71-9035

15 August 2006

**Subject: Additional Supportive Information for the Model 680-OP Type B Container**

- A List of Affected Pages
- B Revised Pages 1-1, 2-1, 2-5, 2-10 and 8-3 of SAR Revision 10
- C Drawing R680-OP Rev G

TITLE		MODEL 680-OP	
SIZE	DWG. NO.	R680-OP	
A	SCALE: NONE	SHEET 1 OF 7	
			REV G

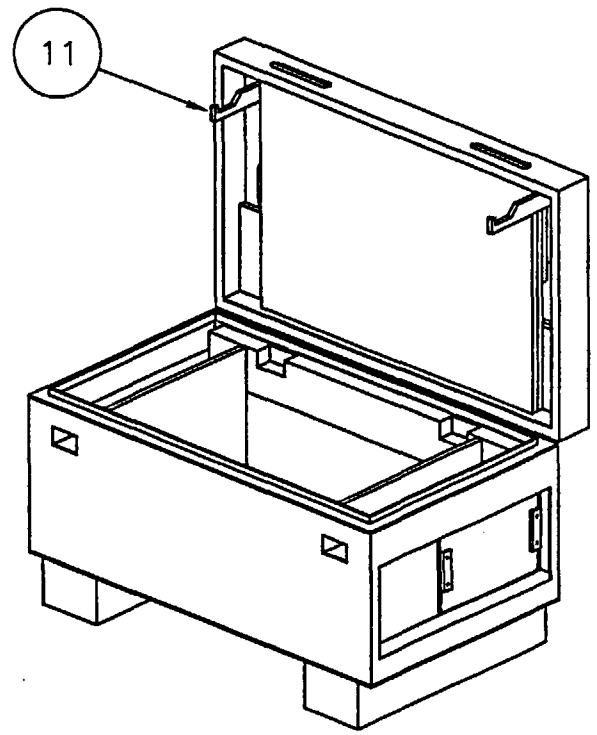
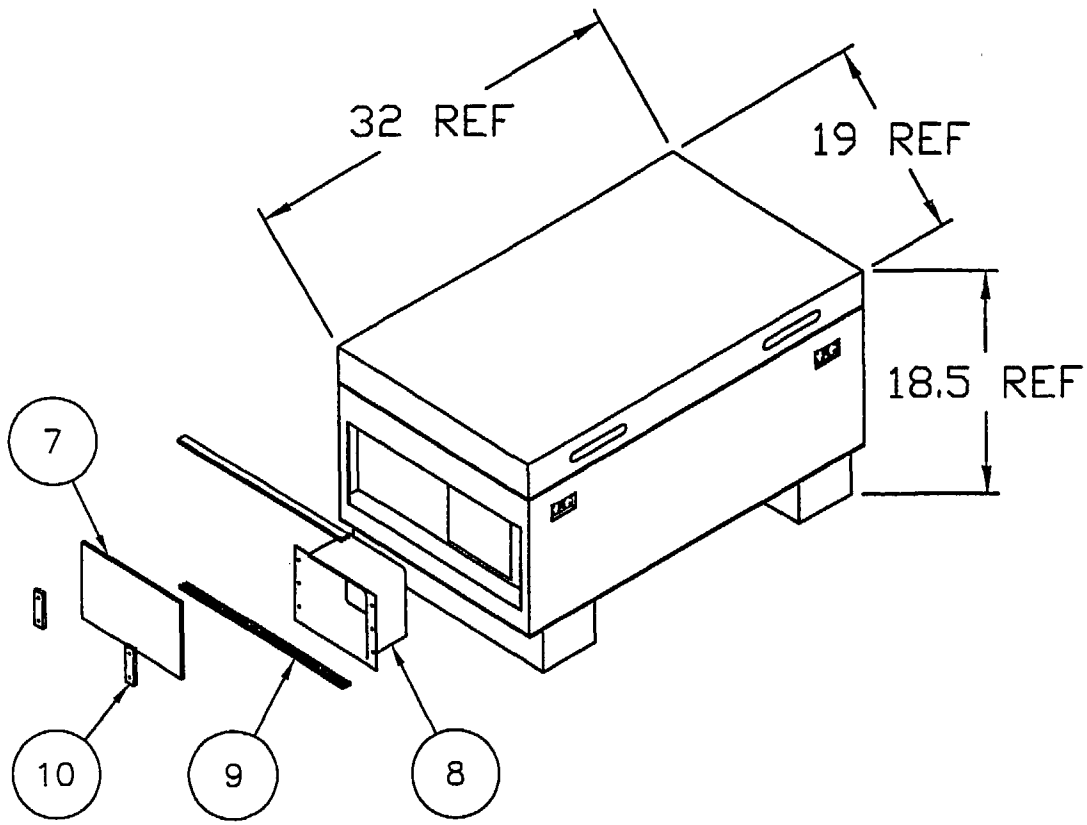
- Section 8.2.3 is modified to incorporate the lock assembly component test as requested by your staff.
- Pages 1-1, 2-1, 2-5, 2-10 and Drawing R680-OP are revised to reflect maximum package weight as 615 lbs instead of 625 lbs.

- NOTES:
1. NOTES APPLY TO ALL PAGES.
  2. ALL WOOD EXTERIOR GRADE C-C, GROUP 1 OR BETTER PLYWOOD.
  3. WOOD TOLERANCES  $\pm 3/16"$ .
  4. "BASKET" LOAD RATING OF 2000LBS. MINIMUM.
  5. NAME PLATE ON FRONT.
  6. MAX. PACKAGE WEIGHT 615 LBS.  
WEIGHT OF STEEL BOX 68-75 LBS.
  7. WEIGHT OF STEEL BOX, WOOD, & FOAM - 130-150 LBS
  7. TAMPER INDICATOR HOLES DRILLED AS SHOWN, ON BOTH SIDES OF DEVICE.
  8. OPTIONAL TAMPER INDICATOR WIRE HOLES; DRILL 4  $\phi 1/8"$  HOLES APPROXIMATELY WHERE SHOWN.
  9. ALL STEEL TO BE COLD ROLLED STEEL, COMMERCIAL QUALITY (SAE 1008).
  10. ALL PERSONNEL QUALIFICATIONS, WELDING & EXAMINATION PROCEDURES FOR OVERPACK BOXES MANUFACTURED ON OR AFTER 21 NOV 05 ARE IN ACCORDANCE WITH THE REQUIREMENTS OF THE AWS. WELDING ON THE OVERPACK BOXES MANUFACTURED BEFORE 21 NOV 05 WERE INSPECTED BY AWS CERTIFIED WELD INSPECTORS.
